The author proposed a revised version of the manuscript that addresses the comments raised by both reviewers. The manuscript is now more balanced and clearer, and its overall quality increased significantly. As mentioned in my first review, the manuscript presents a precious dataset together with an analysis of time series of temperature and currents from deep observatories across the mediterranean Sea. The contribution of the article is useful, and I would therefore recommend it for publication after a few minor changes and clarification that I described below.

For a better clarity I will follow the numeration used by the authors to answer the first round of my review. My new comments will be written in green, while the author's response will be in black.

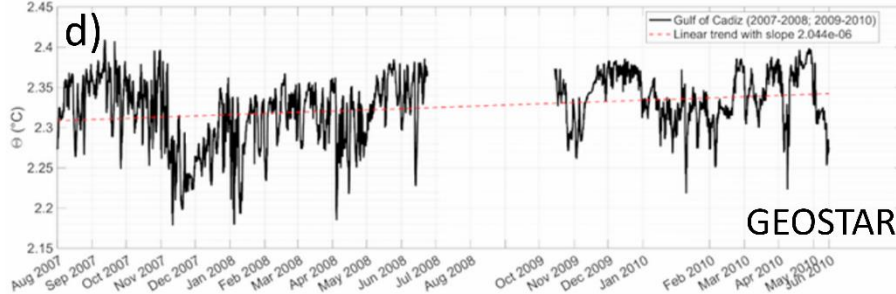
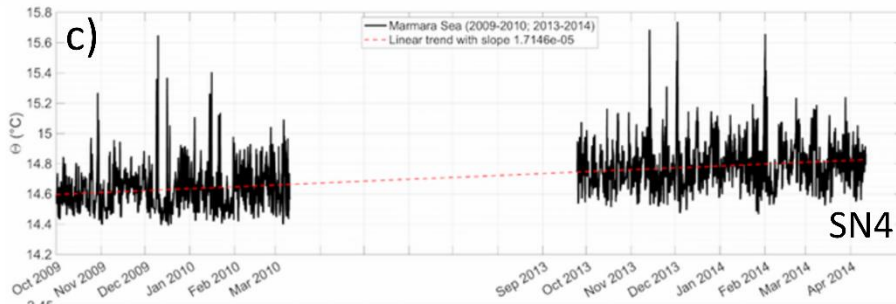
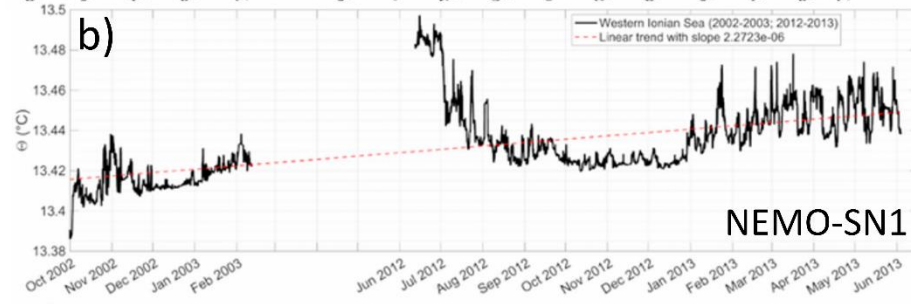
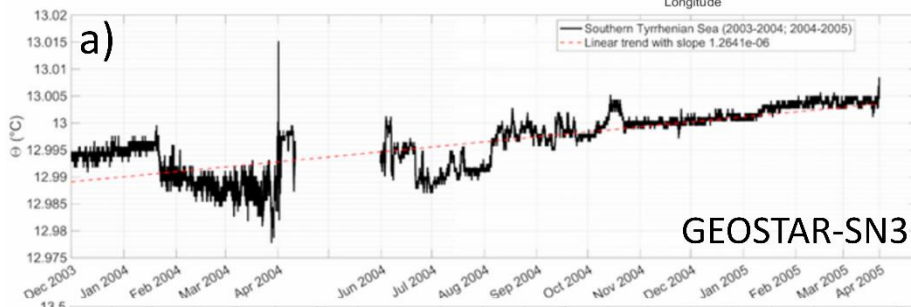
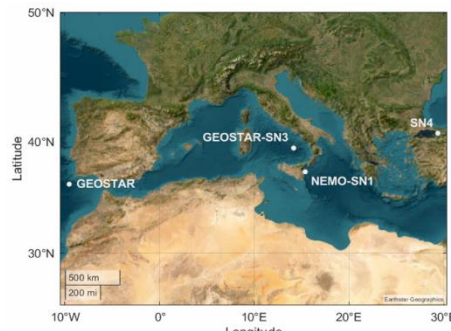
6. *The hodographs were generated using the JLAB hodograph routine, part of a toolbox specifically developed for oceanographic applications, which plots the eastward velocity component against the northward component, i.e., a Cartesian U-V hodograph. Figure 7 has been improved following reviewer suggestion.*

The author responded clearly to my comments concerning convention used for the hodograph. The unity of x and y axis were changed to m/s.

Nevertheless, despite the improvements made to Figure 7, it is still hardly readable in a printed version of the manuscript. The legend of the different time series are small, as well as tick labels, and colorbar label. I understand the difficulty that the author is facing to present two time series and a map in the horizontal. I propose an alternative on the next page for the layout which would make the different elements easier to read.

I also detected that σ_{2000} , σ_0 and σ_{3000} are used in this figure. I would recommend the author to change “ σ_{2000} , calculated with reference pressure of 2000 dbar” (L.425) to “ σ_0 , σ_{2000} , and σ_{3000} , calculated with reference pressure of 0, 2000, and 3000 dbar respectively”.
